Project	IEEE 802.16 Broadband Wireless Access Working Group < http://ieee802.org/16 >	
Title	Comments on IEEE 802.16j Channel Models in IEEE802.16j-06/013	
Date Submitted	2006-09-23	
Source(s)	<p>Peter Wang, peter.wang@nokia.com Nokia Inc. 6000 Connection Dr Irving, TX 75039, USA.</p> <p>I-Kang Fu, IKFu@itri.org.tw National Chiao Tung University / Industrial Technology Research Institute 1001 Ta Hsueh Road, Hsinchu, Taiwan 300, ROC.</p> <p>Wendy C Wong, wendy.c.wong@intel.com Intel Corporation 2200 Mission College Blvd., Santa Clara, CA 95054, USA.</p> <p>David Chen, david.t.chen@motorola.com Motorola Inc 1441 W. Shure Drive, Arlington Heights, IL 60004 USA.</p> <p>Mike Hart, Mike.Hart@uk.fujitsu.com Sunil Vadgama Fujitsu Laboratories of Europe Ltd. Hayes Park Central Hayes End, Middx., UB4 8FE, UK.</p> <p>Jun Bae Ahn, jbahn@st.co.kr SOLiD Technologies 10th Fl., IT Venture Tower East Wing, 78 Garak-Dong, Dongpa-Gu, Seoul, 138-803 Korea.</p>	<p>Yong Sun, Sun@toshiba-trel.com Khurram Rizvi Dharma Basgeet Toshiba Research Europe Limited 32 Queen Square Bristol BS1 4ND, UK</p> <p>Youn-Tai Lee, lyt@nmi.iii.org.tw Institute for Information Institute 8F., No. 218, Sec. 2, Dun-Hwa S. Rd.,

Figure.4 Type-F NLOS Urban Macro-cell Scenario

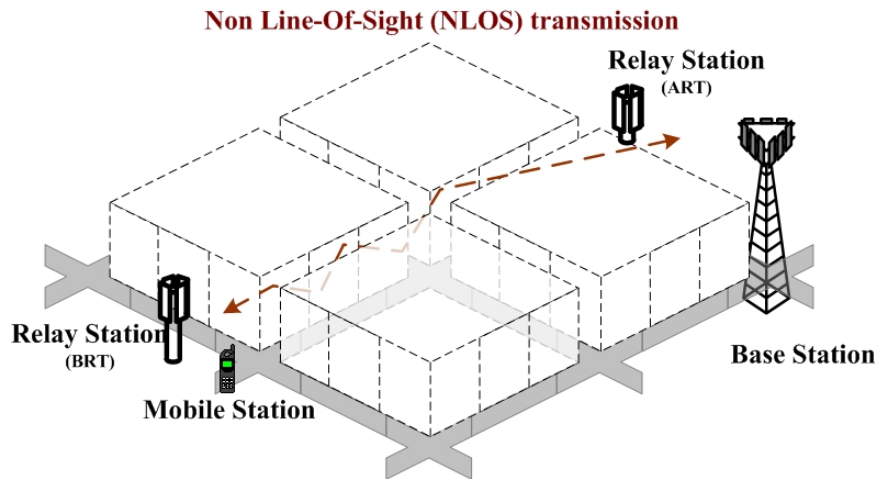
6. Comment on section “2.1.2.5 Type-E:...” in IEEE 802.16j-06_013 document

We propose to change “2.1.2.5 Type-E:...” to “2.1.2.4 Type-F NLOS (ART-BRT) for urban macro-cell scenario”. We adapt WINNER C2 model (urban macro-cell model) and the details are given as following:

2.1.2.4 Type-F: BS-RS, BS-MS, RS-RS, RS-MS, NLOS (ART-BRT) for urban macro-cell scenario

The following path-loss model is considered for Type-F NLOS scenario:

$$Pathloss(d) = 38.4 + 35 \cdot \log_{10}(d) \text{ dB}$$

where d is the distance in meter and $50\text{m} < d < 5\text{km}$.

For this scenario, NLOS transmission is the general case. We may also use 2GHz COST231-Hata model with free-space correction to model path-loss around 5 GHz for Type-F urban macro-cell scenario. When using different carrier frequency, the following frequency correction factor can be added in previous path-loss equation:

$$C(f_c) = 20 \cdot \log_{10}(f_c/5)$$

Figure.6 Type-G LOS Scenario

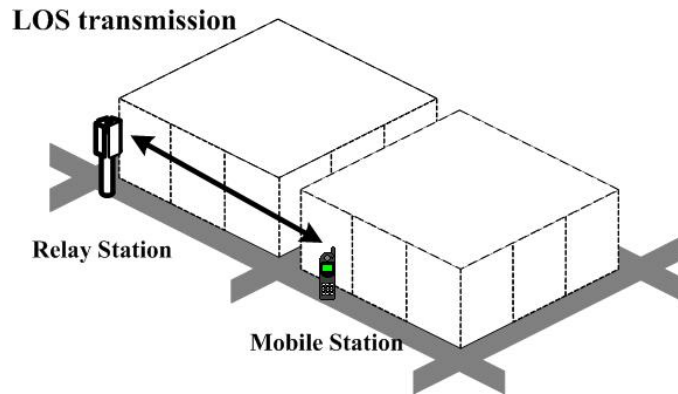
7. Comment on “2.1.2.6 Type-F: RS↔MS, LOS (BRT-to-BRT)” and “2.1.2.7 Type-F: RS ↔ MS, NLOS (BRT-to-BRT) in IEEE 802.16j-06_013 document

We suggest to merge the sections of “2.1.2.6 Type-F: RS↔MS, LOS (BRT-to-BRT)” and “2.1.2.7 Type-F: RS ↔ MS, NLOS (BRT-to-BRT) from IEEE 802.16j-06_013 baseline document together and become one section called “2.1.2.5.Type-G: RS-RS; RS-MS, LOS/NLOS (Urban Micro-cell BRT-to BRT model)”. We suggest using WINNER B1 LOS/NLOS scenario (urban micro-cell model) and removing the Berg’s model due to its high complexity for simulation. The details WINNER B1 model is as following:

For LOS case as in Figure 6:

$$PL(d) = 22.7 \log_{10}(d) + 41.0 \text{ dB} \quad \text{for } 10m < d < 650m$$
